MIL-I-3949D
AMENDMENT 2
27 April 1984
SUPERSEDING
INTERIM AMENDMENT 1
28 October 1983

MILITARY SPECIFICATION

INSIGNIA, RANK, OFFICER'S METAL;
GENERAL SPECIFICATION FOR

This amendment forms a part of Military Specification MIL-I-3949D, dated 31 December 1971, and is approved for use by all Departments and Agencies of the Department of Defense.

Figure 1

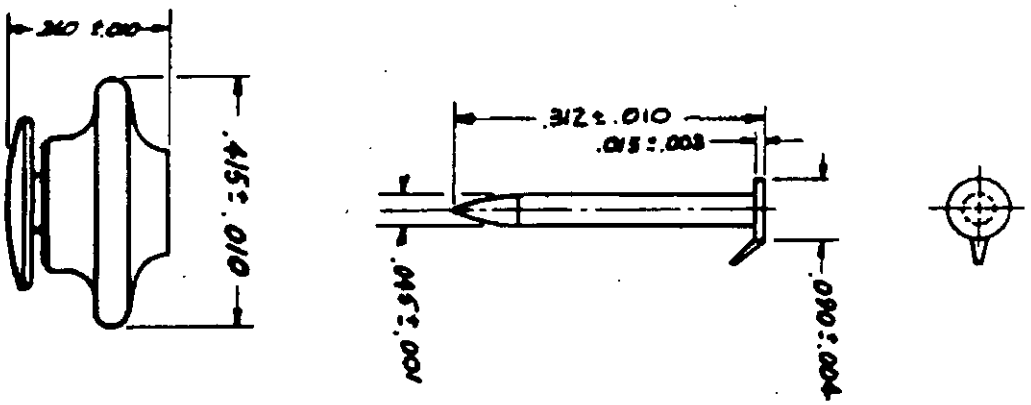
Delete "Figure 1, B-13-12, dated 14 Dec 70" and substitute "Figure 1, B-13-12, dated 16 Mar 79".
